Final Plat
SUBDIVISION REPORT

SUBDIVISION COMMITTEE
METROPOLITAN AREA
PLANNING COMMISSION

S/D No.: 85-95 Name: GRUNDMAN ADDITION

FINAL PLAT

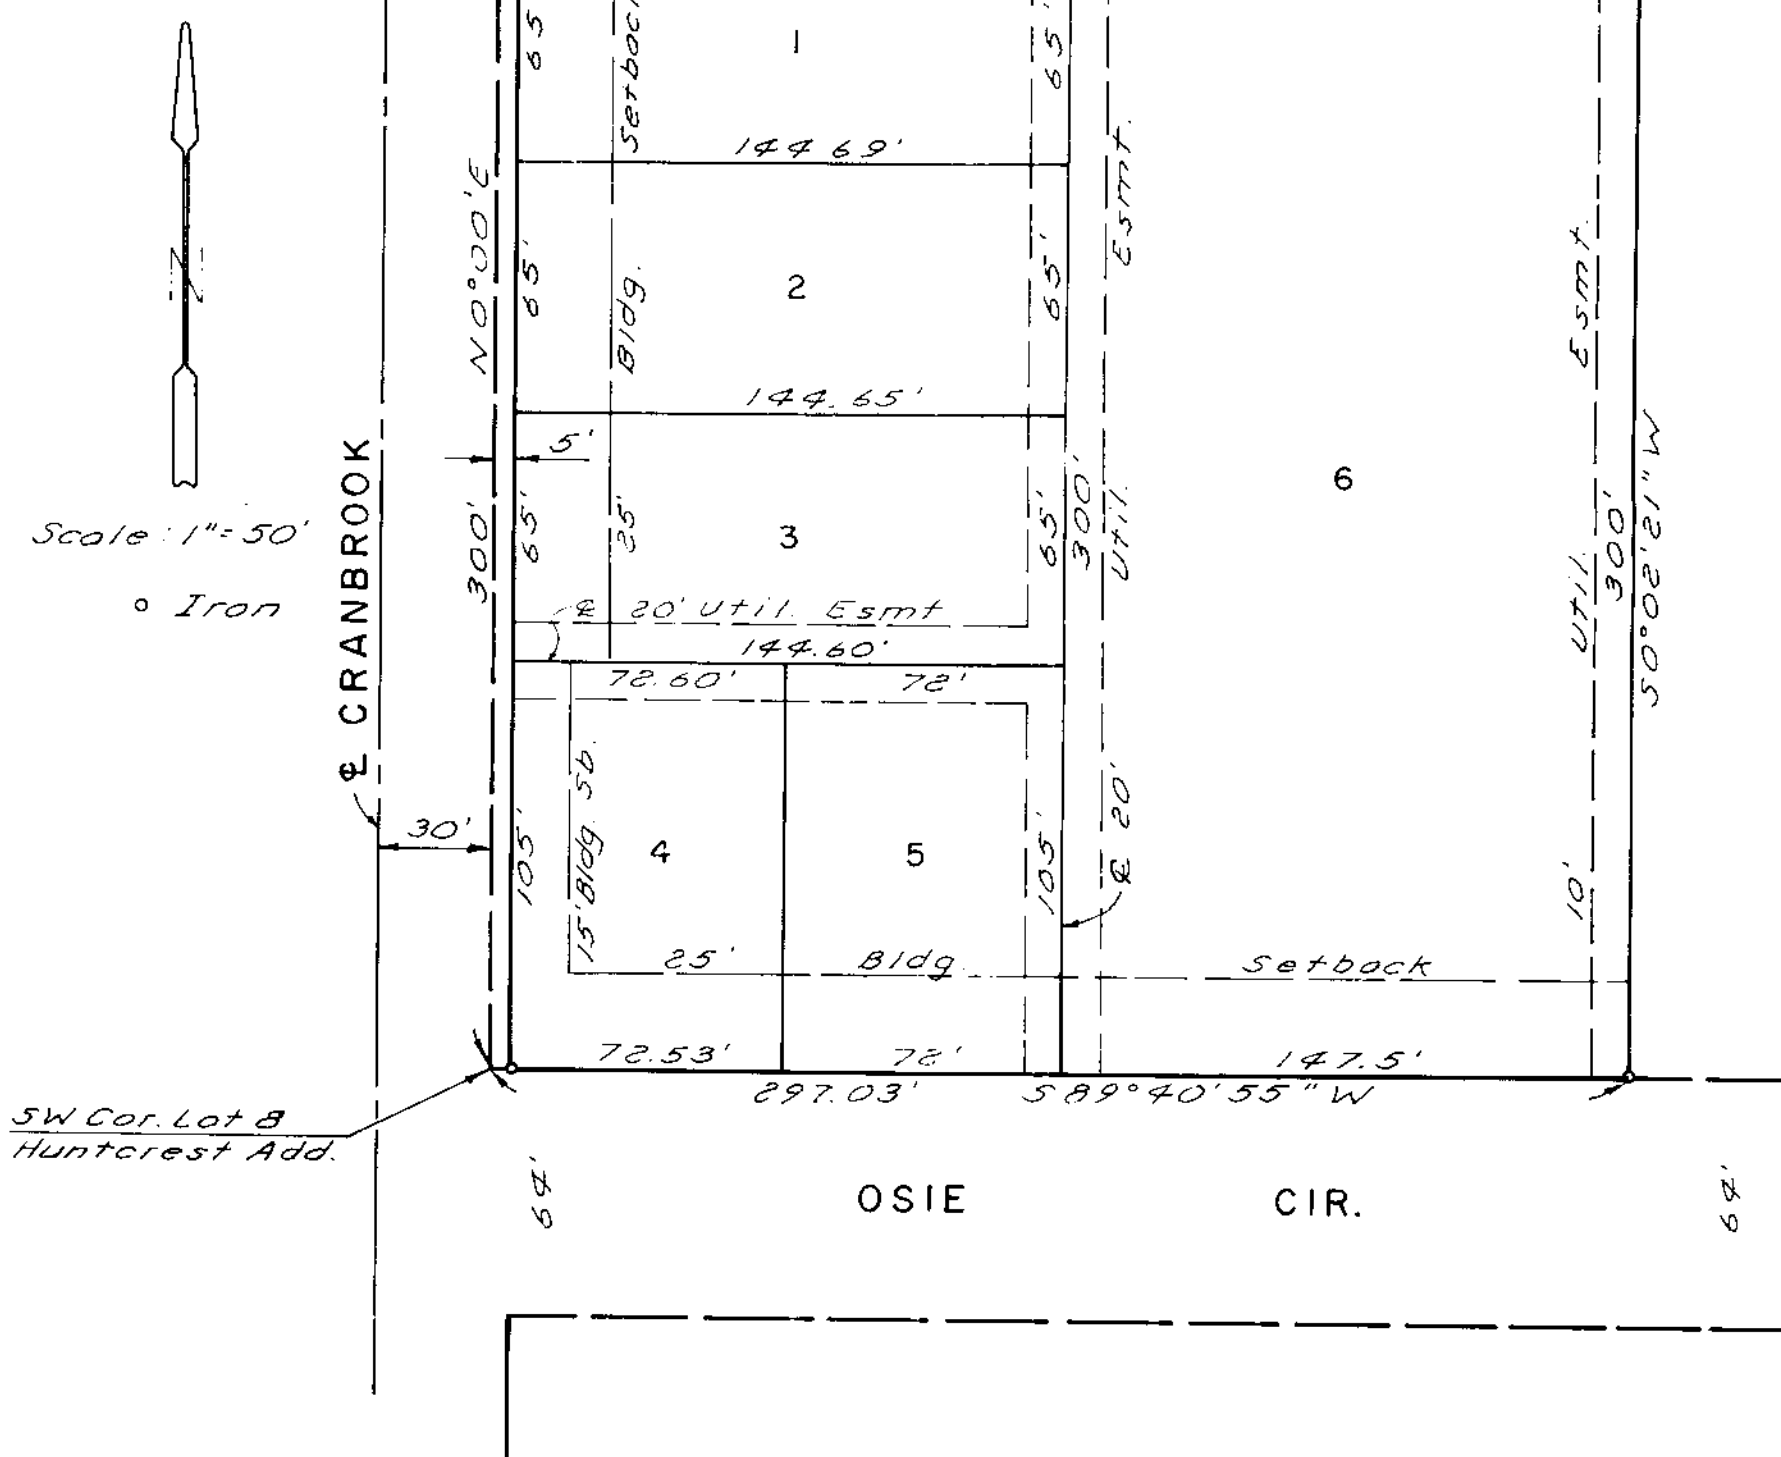
- A. Since this property is adjacent to the City of Wichita, the applicant shall request annexation into the City. Upon annexation, the "R-1" property will be zoned "AA", and thereby permit the lot sizes being proposed. The final plat shall not be scheduled for B.C.C. review until annexation has occurred.

- B. The applicant shall guarantee the extension of sanitary sewer to serve the lots being platted.
- C. The applicant shall guarantee any drainage improvements required by the platting of this property.

- D. The applicant shall submit a sidewalk certificate stating that a sidewalk will be constructed on Cranbrook (collector street) adjacent to Lots 1-4 at the time of site development.

- E. If improvements are guaranteed by petition, a notarized certificate listing the petitions shall be submitted to the Planning Department for recording.

- F. Since the 30-foot building setbacks platted from Osie Circle are being reduced to 25 feet by this replat, the engineer's text on the final plat tracing shall be amended to reference the vacation of building setbacks by virtue of K.S.A. 12-512(b).

- G. Perimeter closure computations shall be submitted with the final plat tracing. Section 5-101(C).
- H. Recording of the plat within 30 days after approval by the Board of City Commissioners.

- I. The representative from the City Engineer's office should be prepared to comment on the status of the applicant's drainage plan. Specifically, are any drainage guarantees required?

- J. The representative from the City Engineer's office should be prepared to comment on the status of the existing paving petition for Osie Circle and the status of the petition on file for extension of a water line in this street. Specifically, does this applicant need to sign or revise the street paving and water petitions for adjacent Osie Circle?
